IN THE DRAWINGS

REMARKS

FIG.3

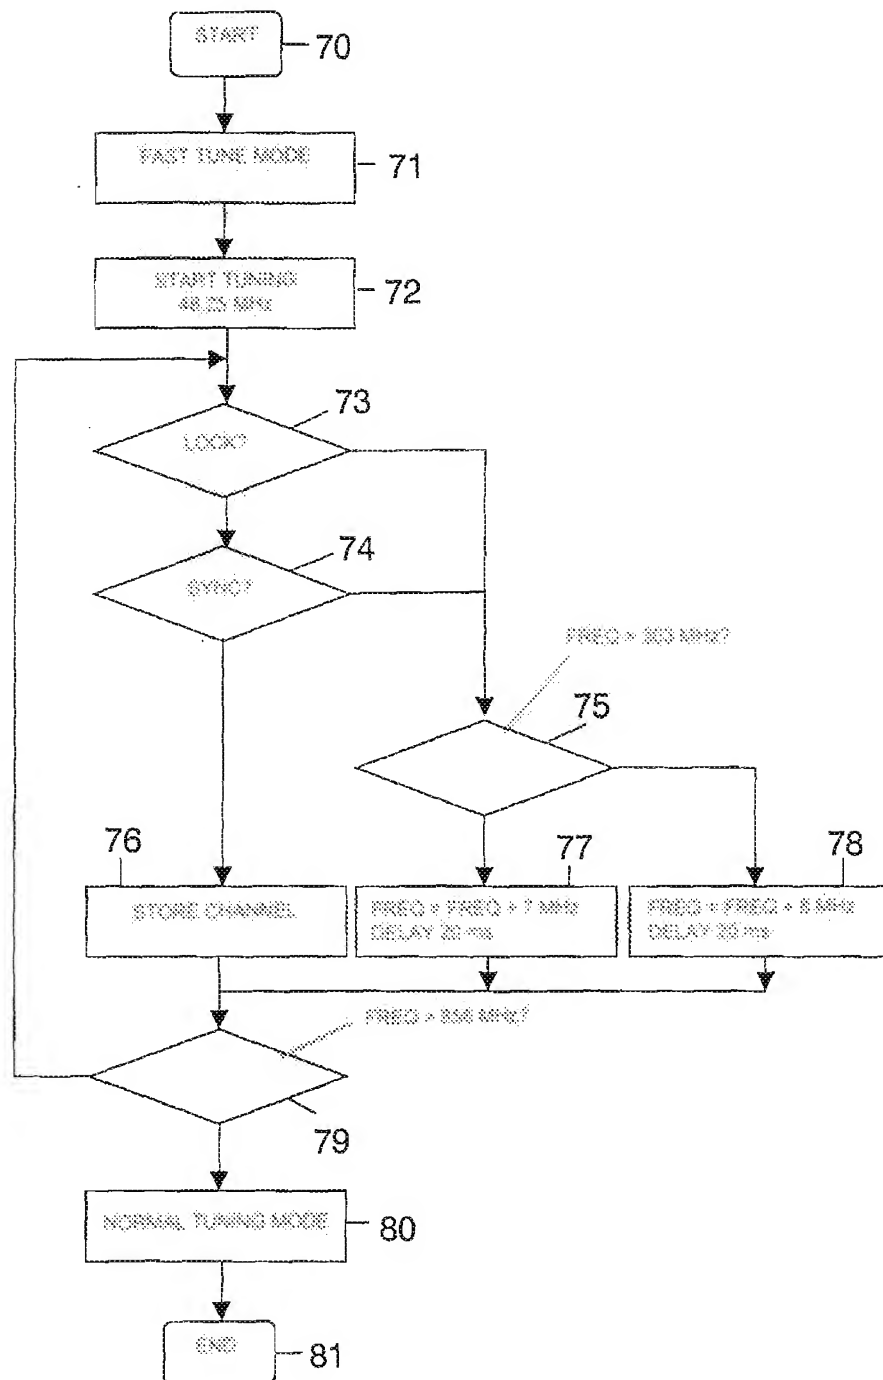
Applicants propose to label the blocks in Figs. 1-3 and to revise Fig. 1 in accordance with the accompanying ANNOTATED SHEETS SHOWING CHANGES.

The Examiner has objected to the drawing in that the added arrow from the top of AFT 32 over to the top of PLL 31 is New Matter. Enclosed herewith are new ANNOTATED SHEETS SHOWING CHANGES and REPLACEMENT SHEETS in which said arrow has been eliminated.
